BCA 2022 ASSESSMENT REPORT

**Project Echidna
Eastern Creek Drive, Eastern Creek**

**Prepared For:
Genton/Arup**

Date: 18 August 2022

Figure 2 – Perimeter Vehicular Access Assessment

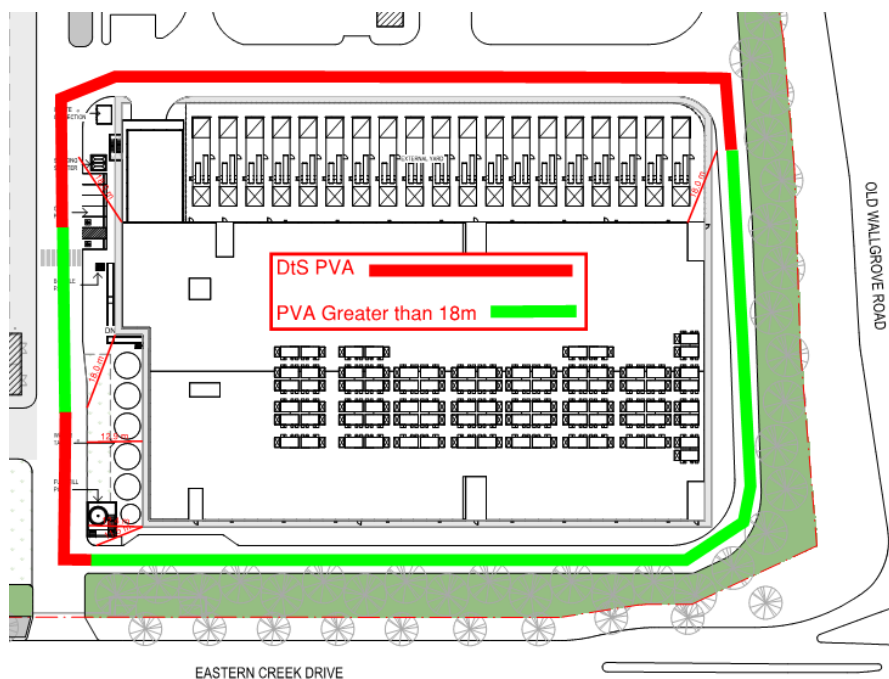
Comments: The proposed building does not comply with the provisions of C3D5 and thus the following non-compliance issues are required to be addressed as a Performance Solution by the Fire Engineer to demonstrate compliance with Performance Requirement C1P9:

- Perimeter Vehicular Access is greater than 18m from the building along the North Western and Eastern sides of the building.
